PRODUCT CHANGE NOTIFICATION

Dimension Change for Select Bourns® High Power Current Sense Chip Resistors

Model CRM2512 Series

N2105

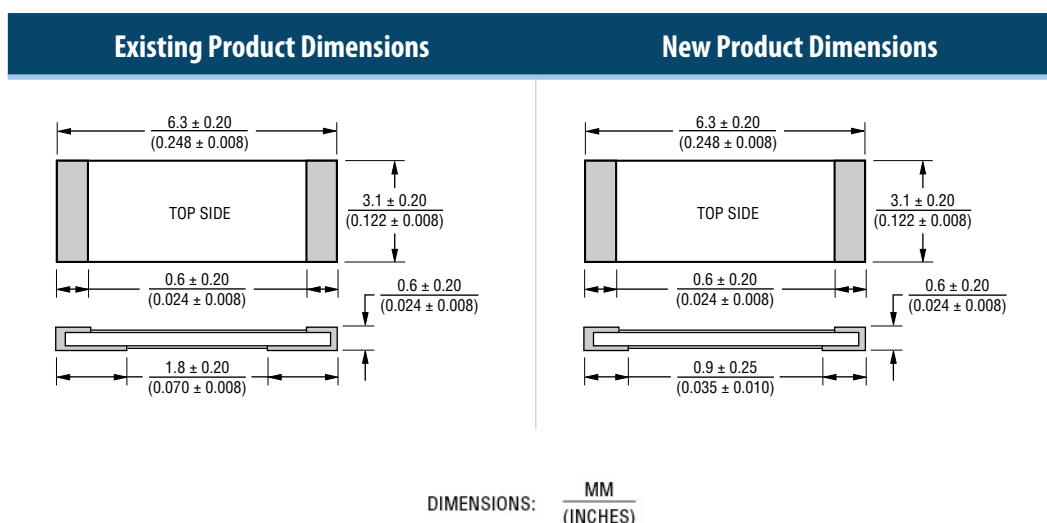
Riverside, California – March 18, 2021 – Effective June 30, 2021, the length of the bottom terminal of select Bourns® Model [CRM2512](#) High Power Current Sense Chip Resistors will change from 1.8 ± 0.2 mm to 0.9 ± 0.25 mm. The purpose of this change is to standardize the product's terminal to common industry specifications. The product's form will change because of the change in appearance of the bottom terminal. However, the fit will not change as the recommended solder pad's layout dimensions for the customer PCB remain the same.
